Date	Description
2018.02.05	DD Submittal
2018.xx.xx	Bid Documents

PN #17-003  
**DESIGN DEVELOPMENT**

**A0.1**  
MASTER PLAN

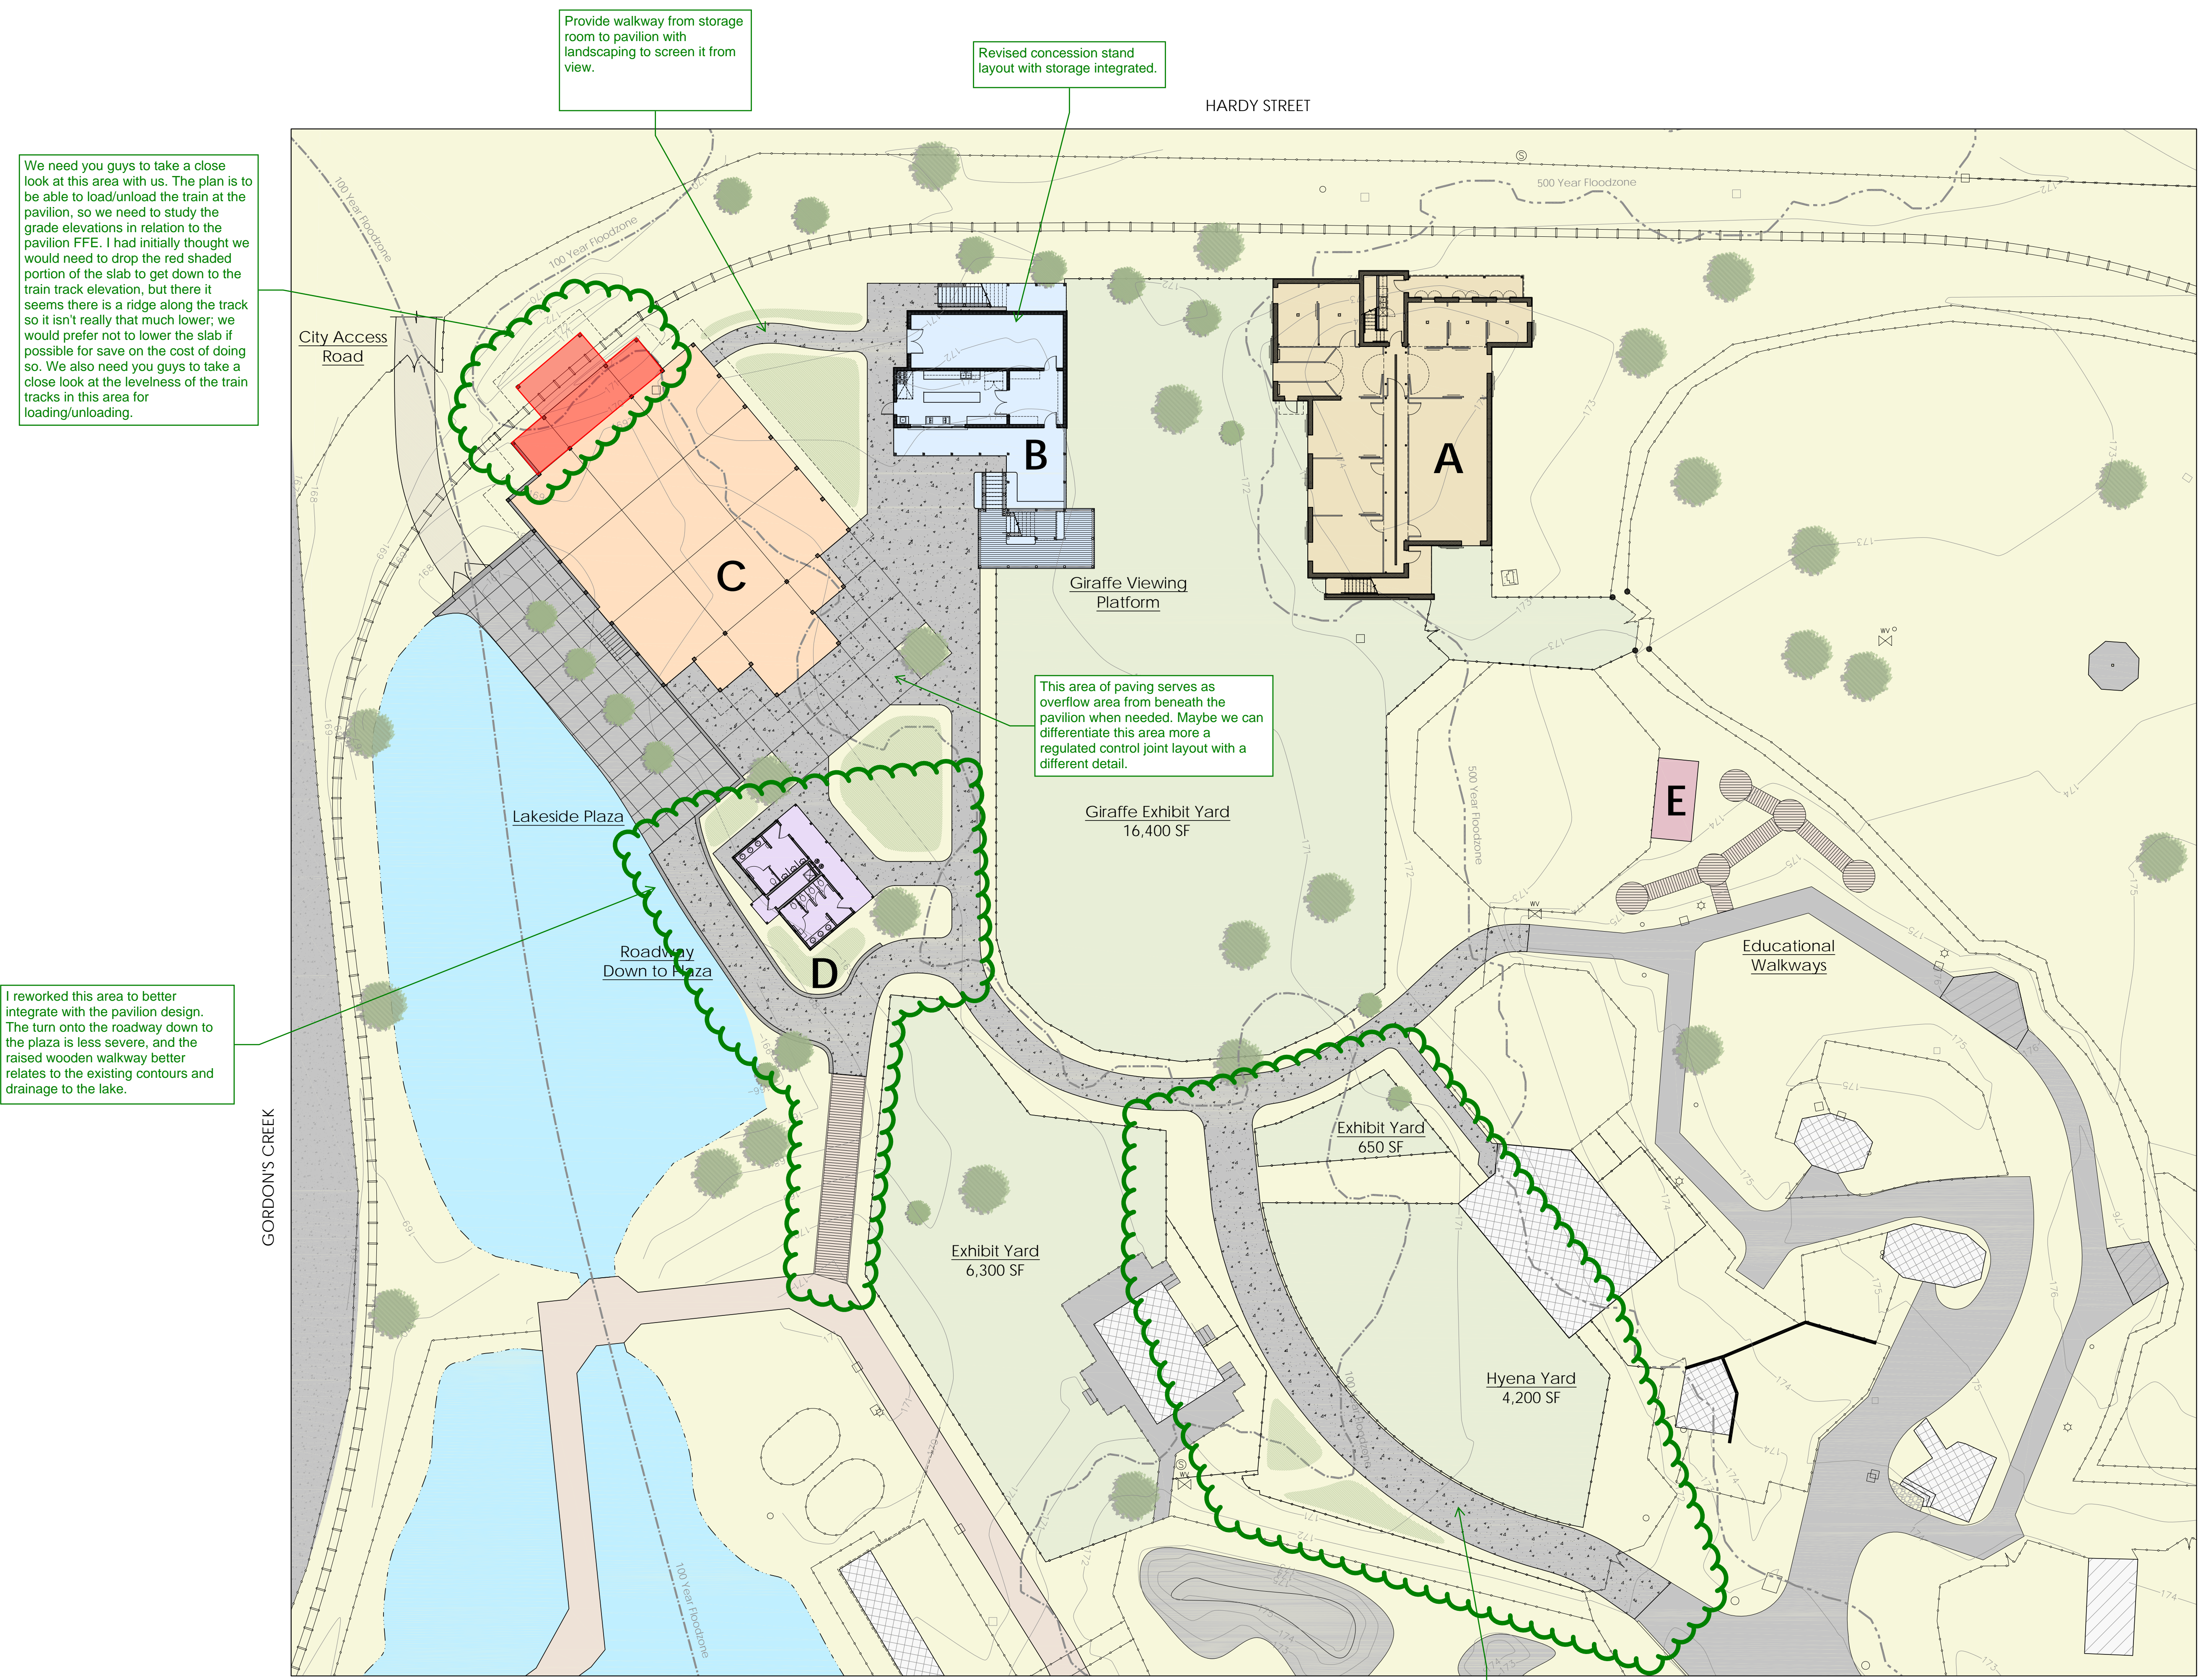
We need you guys to take a close look at this area with us. The plan is to be able to load/unload the train at the pavilion, so we need to study the grade elevations in relation to the pavilion FFE. I had initially thought we would need to drop the red shaded portion of the slab to get down to the train track elevation, but there it seems there is a ridge along the track so it isn't really that much lower; we would prefer not to lower the slab if possible for save on the cost of doing so. We also need you guys to take a close look at the levelness of the train tracks in this area for loading/unloading.

Provide walkway from storage room to pavilion with landscaping to screen it from view.

Revised concession stand layout with storage integrated.

This area of paving serves as overflow area from beneath the pavilion when needed. Maybe we can differentiate this area more a regulated control joint layout with a different detail.

I reworked this area to better integrate with the pavilion design. The turn onto the roadway down to the plaza is less severe, and the raised wooden walkway better relates to the existing contours and drainage to the lake.

New layout for this area provided to us by the zoo.
